Broadcast Products Technical Bulletin 20-2004-137

SUBJECT: **MANUAL CORRECTION—ADDITION OF DOUBLE POLE/NEUTRAL FUSING CAUTION**

MODEL: ***BVM-D9H1A***
BVM-D9H1E
BVM-D9H1U
BVM-D9H5A
BVM-D9H5E
BVM-D9H5U
PVM-9L2
PVM-9L2
PVM-9L2//C
PVM-9L3
PVM-9L3

*Figure 1*

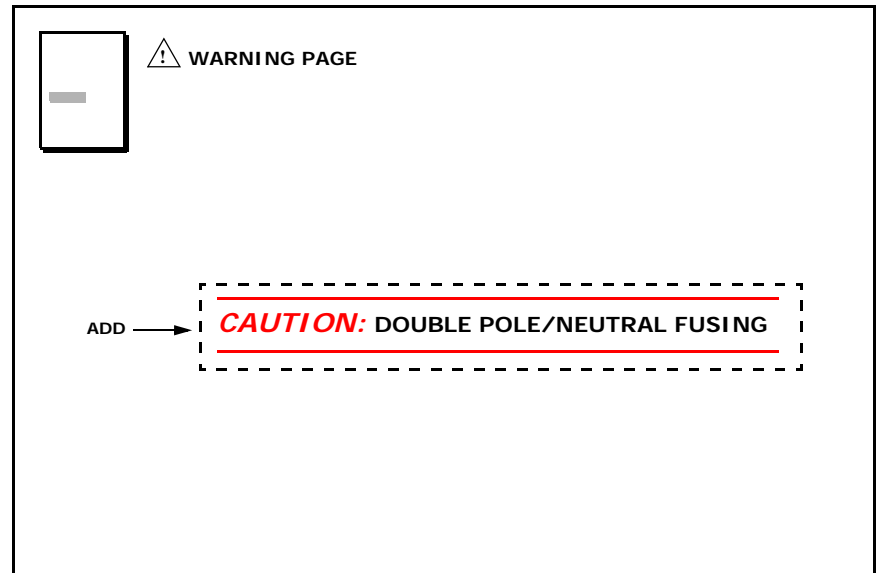
Correct the following manuals as shown in Figure 1.

- *BVM-D9H1A/D9H1E/D9H1U/D9H5A/D9H5E/D9H5U Maintenance Manual, 1st Edition*
- *PVM-9L2 Service Manual*
- *PVM-9L3 Service Manual*
